HOV Lanes on I-20 Westside

P.I. No. 0003165

Value Engineering Study Report

Georgia Department of Transportation, District 7

DESCRIPTION: **CUL-DE-SAC NORTH COUNTY LINE ROAD**

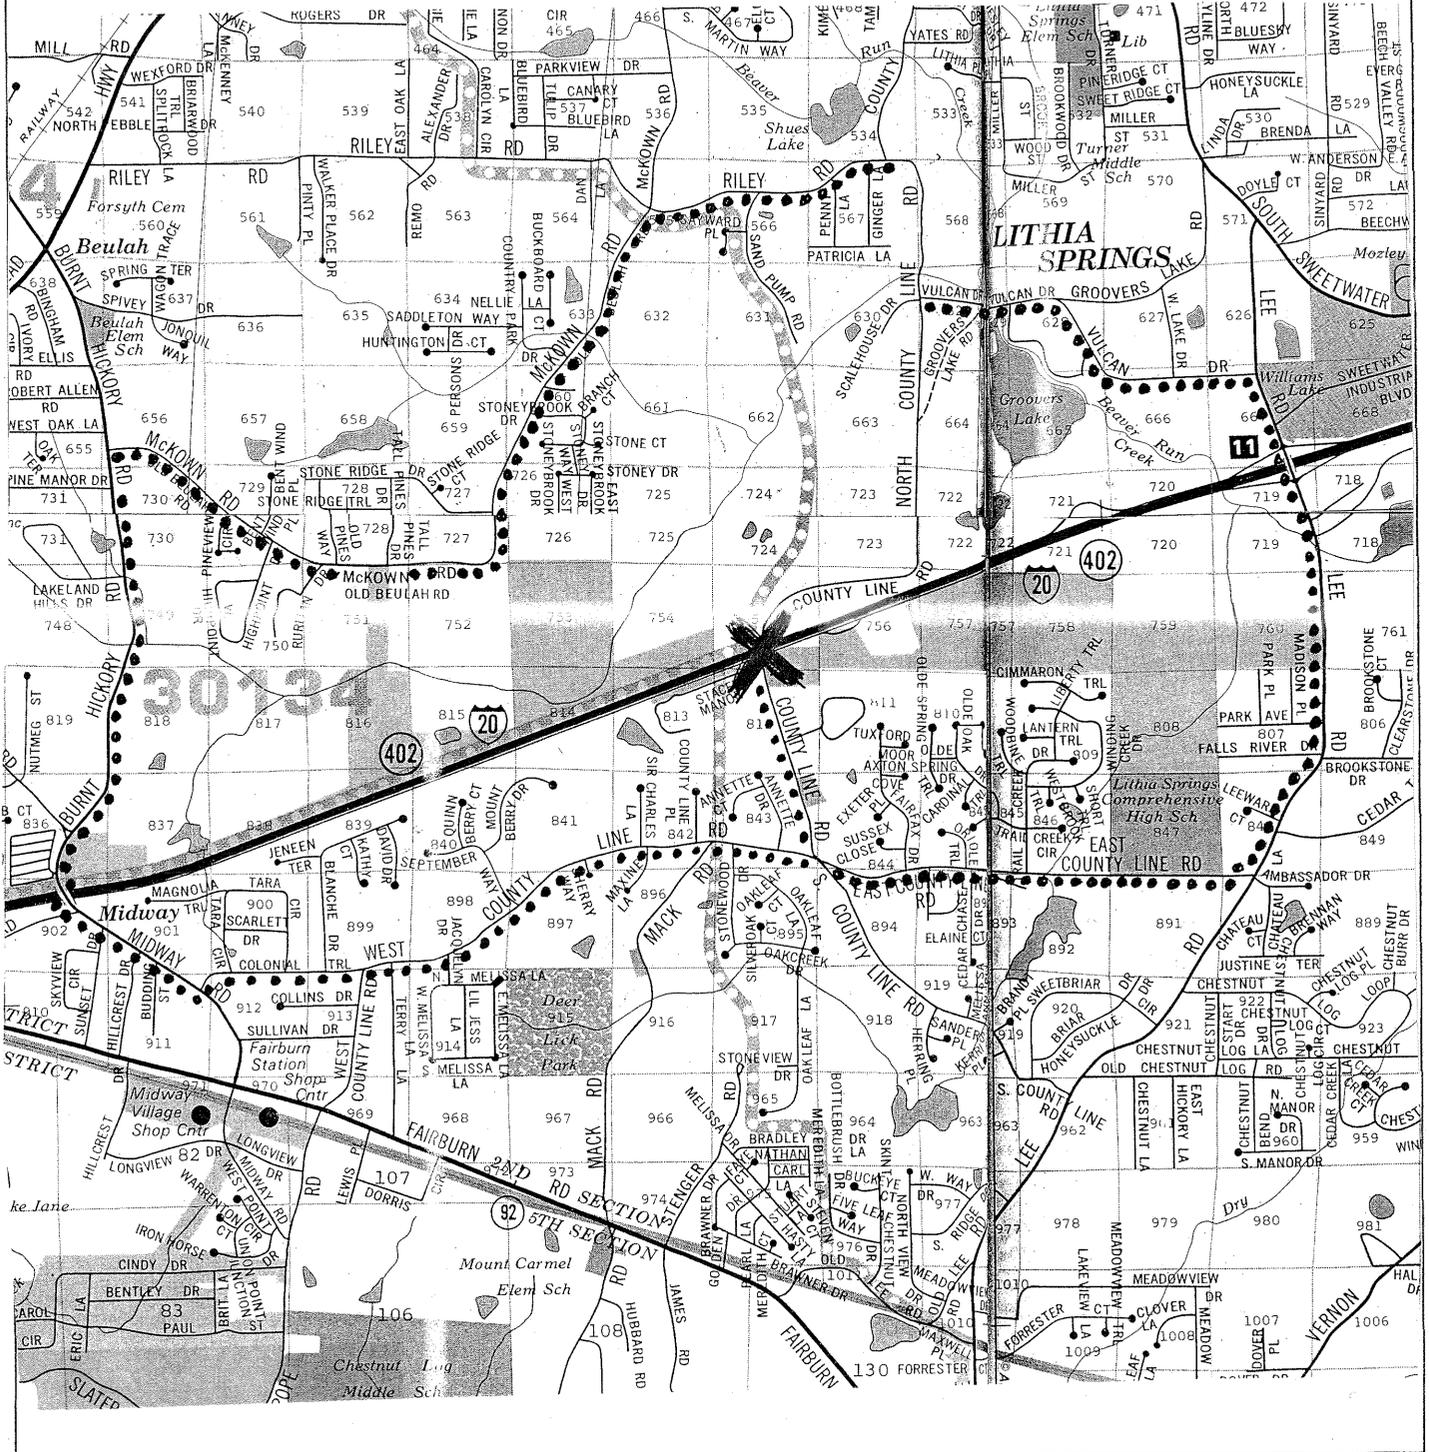
The existing bridge for North County Line Road over I-20 will be replaced due to the addition of HOV lanes along I-20.

Cul-de-sac North County Line Road on either side of I-20 and remove the existing bridge.

Existing traffic north of I-20 can cross using Vulcan Drive or South Sweetwater to Lee Road or access Riley Road and/or McKnown Road to Burnt Hickory Road to cross over I-20. Existing traffic south of I-20 can cross using East County Line Road to Lee Road or West County Line Road to Midway/Burnt Hickory Road.

SR 5 OVER I-20

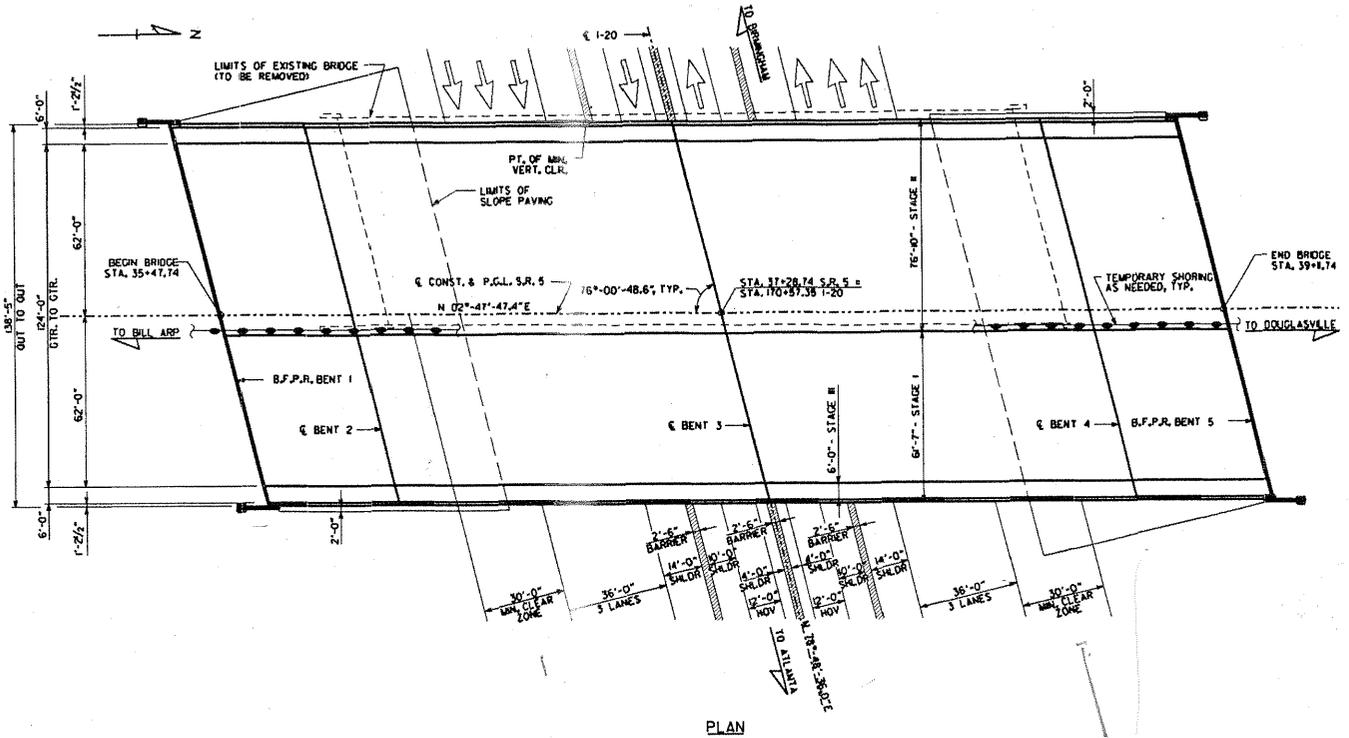
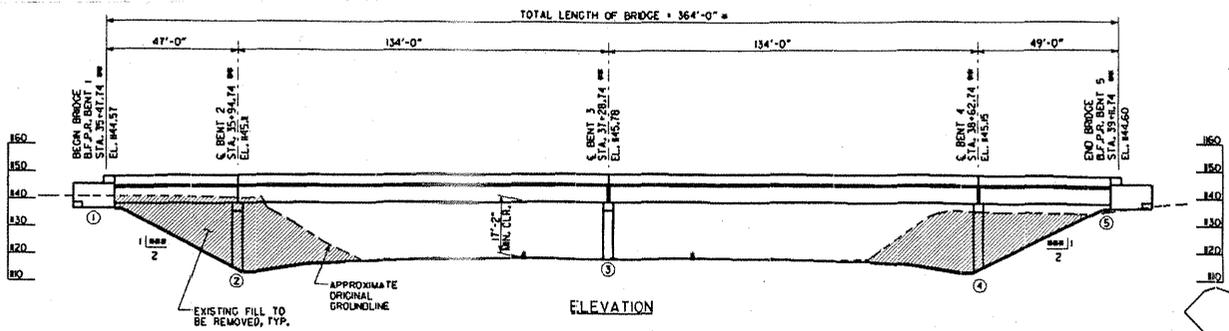
Bridges at Bright Star Road, SR 5, Midway Road, North County Line Road, and the west abutment of Mt. Vernon Road and the Multi-Modal bridge all have end slopes. Except for the North County Line Road Bridge, all others have end slopes with shorter end spans. The remainder of the bridge ends are on MSE walls with a minimum of 30 ft. as the clear zone from the edge of the travelway.

Set bridge ends on MSE walls protected by a barrier in front of the wall adjacent to an outside 14-ft. shoulder.

Shortening bridges with vertical MSE walls that match the cross-section of I-20 bridges over streams saves construction costs. Some bridges have end rolls that can be eliminated by putting walls at the outside shoulders. Other bridges already have MSE wall abutments located behind 30-ft. clear zones. If this is replaced with 14-ft. shoulders, the walls can be brought in and the bridges shortened; however, if there is a definite plan in the future that involves adding outside lanes, then eliminating the clear zone will not be feasible.

$$\text{NEW SPAN LENGTH} = \frac{2' + 4' + 12' + 10' + 2.5' + 14' + 136' + 14' + 1.25' + 6'}{\sin(76.0135^\circ)} = 104.86' \text{ USE } 105'$$

$$\text{BRIDGE CAN BE SHORTEN BY} = 330' - 2 \times 105' = 155'$$

$$\text{DELTA} = \$80.45 \times 155' \times 140' = \$1,765,765.00$$

PROJECT:	HOV LANES ON I-20 WESTSIDE FROM BRIGHT STAR ROAD TO SR 6/THORNTON ROAD <i>Georgia Department of Transportation</i>	ALTERNATIVE NO.:	17
DESCRIPTION:	MIDWAY ROAD AND BURNT HICKORY ROAD BRIDGE DETOUR OVER I-20	SHEET NO.:	1 of 4

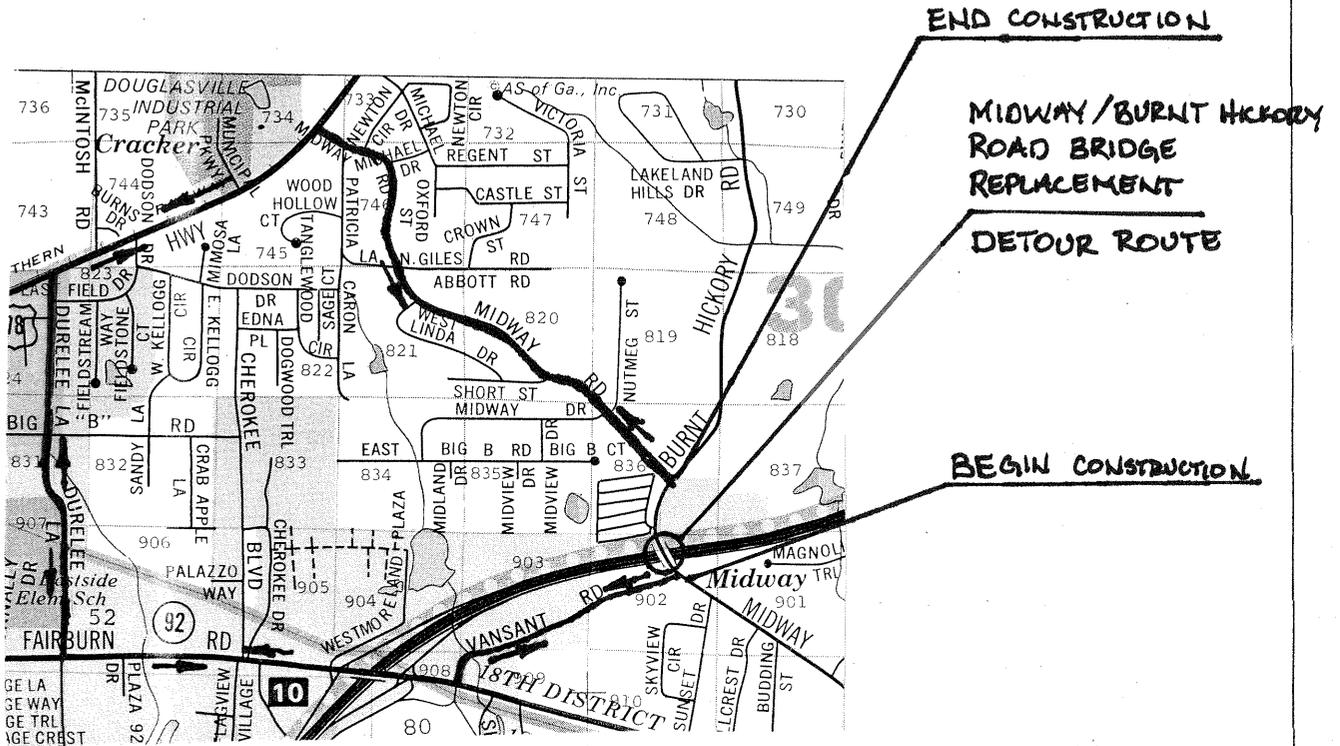
Close Midway Road and Burnt Hickory Road Bridge over I-20 and detour existing traffic. Remove the existing bridge and install the proposed bridge in the existing location. This alternative will reduce and eliminate additional right-of-way requirements along both Midway Road and Burnt Hickory Road.

It is always advantageous to allow the construction contractor to complete the required construction without having to maintain traffic and perform work-arounds. Turning the site over to the contractor for the required construction period is safer for both construction personnel and public travelers and will reduce the amount of time required for completion of the work at hand.

DESCRIPTION: **BUILD ONLY ONE BRIDGE BETWEEN CENTER AND FULL DROP RAMPS AT PROPOSED MULTI-MODAL HOV-ONLY INTERCHANGE** SHEET NO.: **1 of 5**

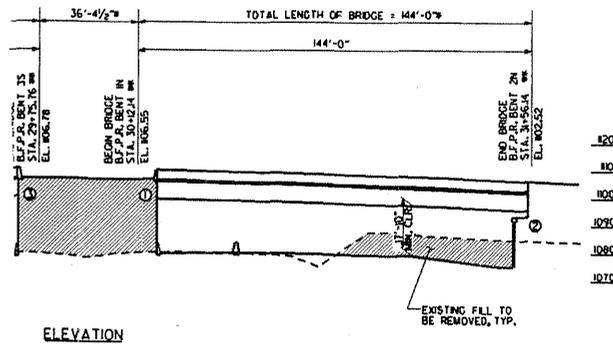
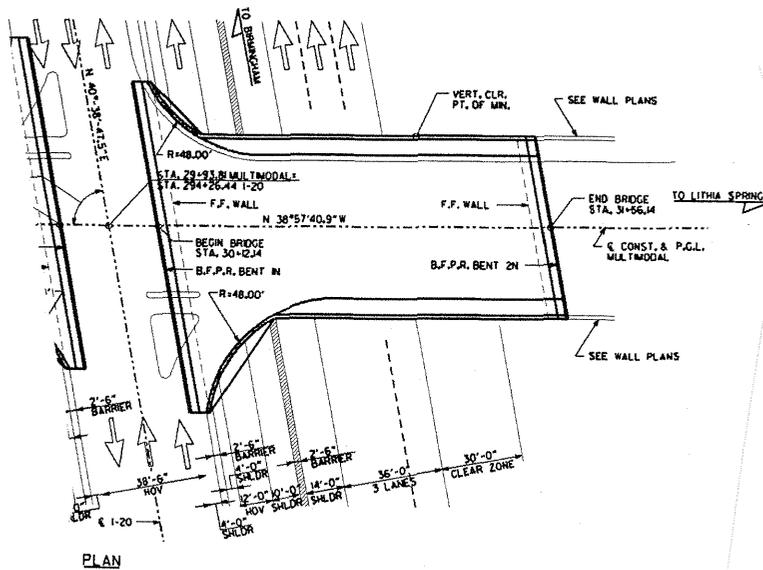
Not building the bridge over I-20 eastbound and the associated roadway to Timber Ridge Drive translates into a large cost savings with minimal impact to traffic flows.
